City of Surrey
PLANNING & DEVELOPMENT REPORT

Application No.: 7921-0149-00

Planning Report Date: April 25, 2022

to permit the development of a 3-storey long-term care facility.

Drawing Title: **LANDSCAPE PLAN**

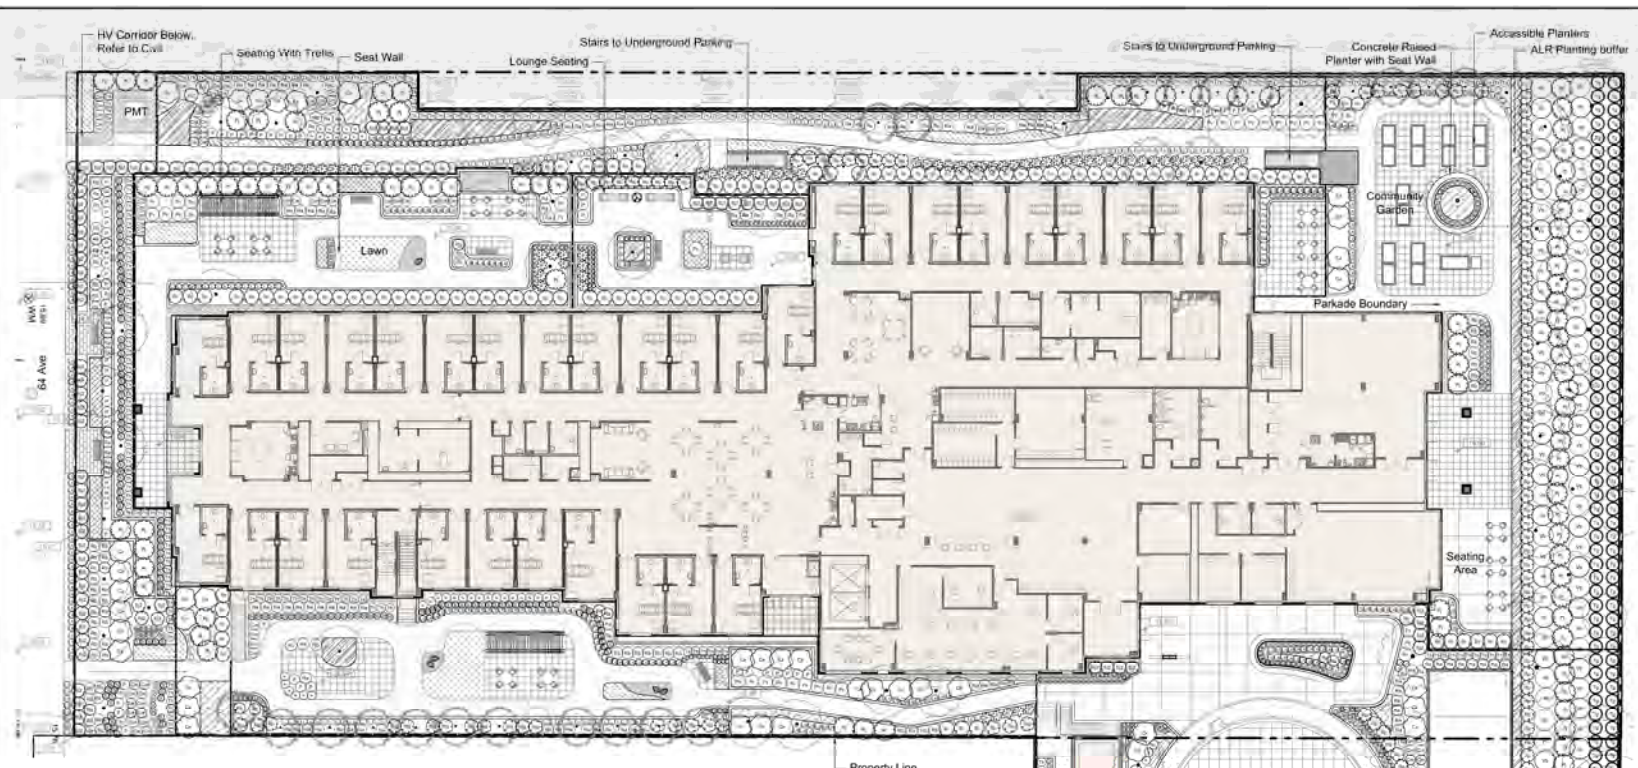
- The courtyard at the SW and SE seems to be somewhat isolated from the building interior and overlook from the nursery stations. Additionally, these exterior spaces are adjacent bedrooms creating potential privacy conflict. Consider larger planters between bedrooms and courtyard areas and consider more direct connections from interior building common space to the exterior spaces.
-

Implemented. Additional seating provided. See drawing L-03

Implemented. Hedge planting provided for more privacy.

Implemented. 8 cm caliper *Carpinus betulus* 'Fastigiata' substituted with *Picea pungens* in this area to provide planting variety and to screen the large blank concrete wall. See drawing L-03.

Drawing Title: FENCING & LIGHTING PLAN

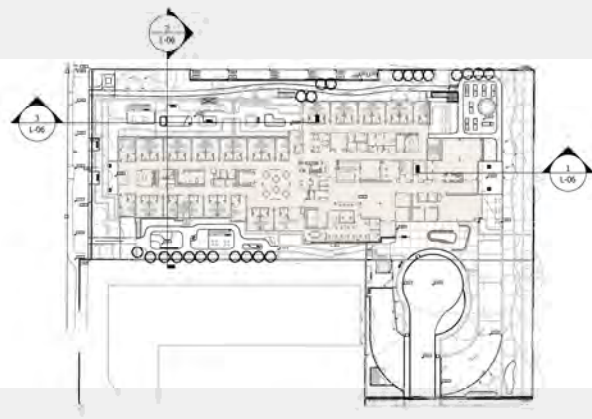
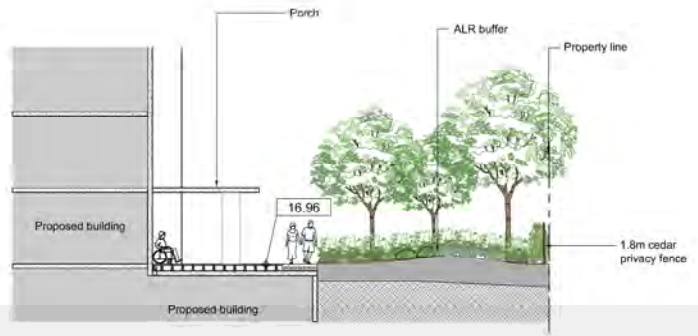
- The landscape package submitted for a Development Permit application is lacking in detail including site lighting plan and fixtures, planting plan with detailed plant list, landscape sections, materials, details.

Implemented. Lighting plan provided. See drawing L-05 Fencing & Lighting Plan. Details of lighting fixtures provided. See detail 1, 2, 7 in LD-03. Detail plant list and full planting plan provided. See drawing L-04. Section of 64th Ave frontage and through courtyards have been provided. See drawing L-06 Sections. Landscape materials and details see drawing LD-01 to LD-03

Implemented. Precedent images for how wood fence transitions to metal fence provided in drawing L-05 Fencing Plan.

Lighting plan provided. See drawing L-05 Fencing & Lighting Plan.

DRAWN BY: JH	CHECKED BY: RC
SCALE: 1:250	PROJECT NO: CA638
SIMPLIFIED SITE PLAN	
SHEET NO:	A1.0a

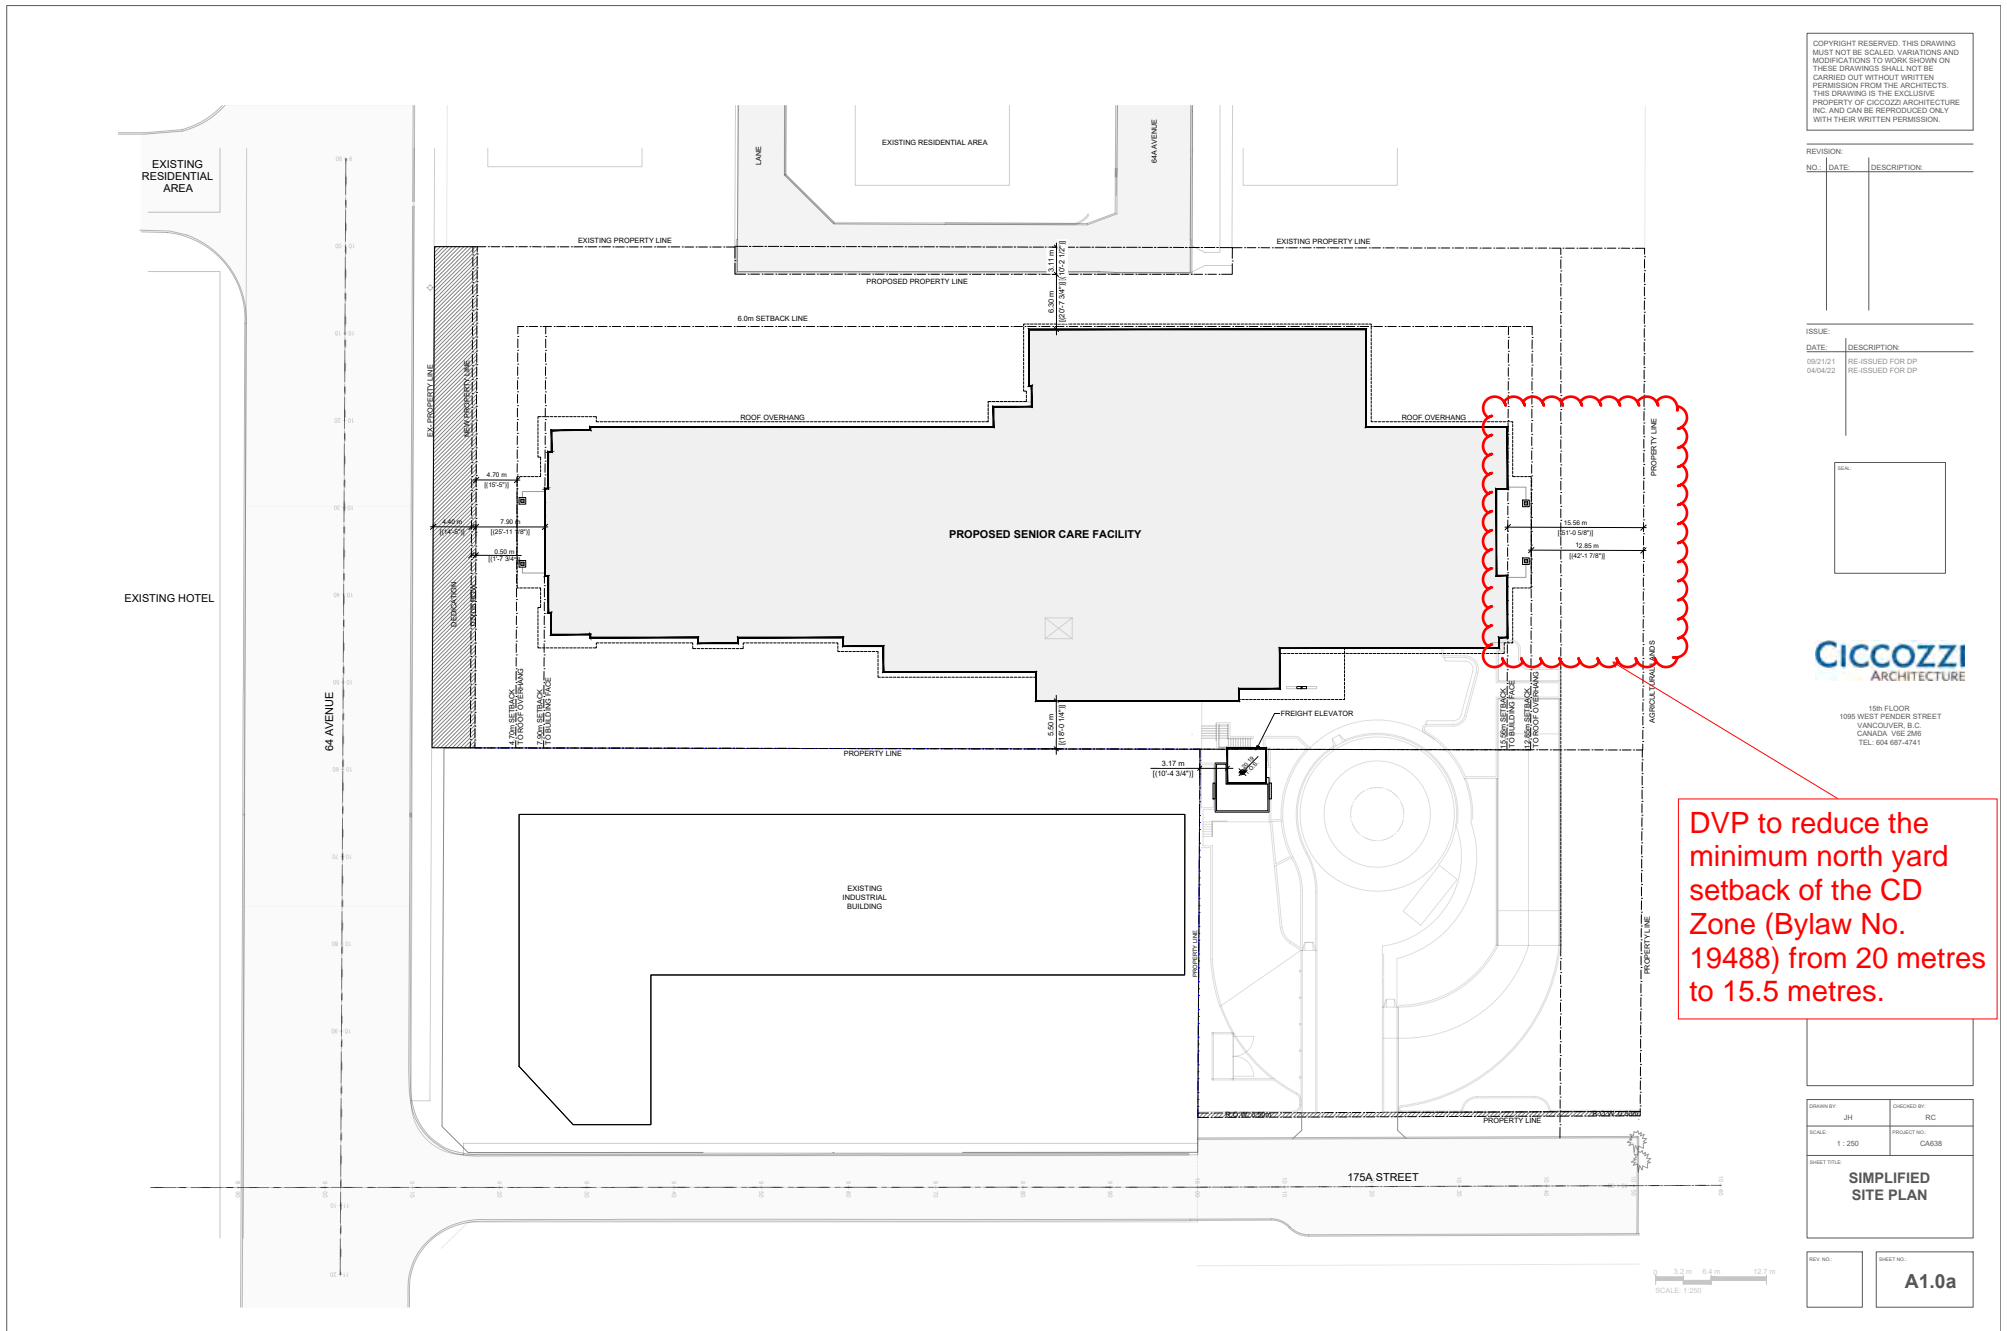
DVP to reduce the minimum north yard setback of the CD Zone (Bylaw No. 19488) from 20 metres to 15.5 metres.
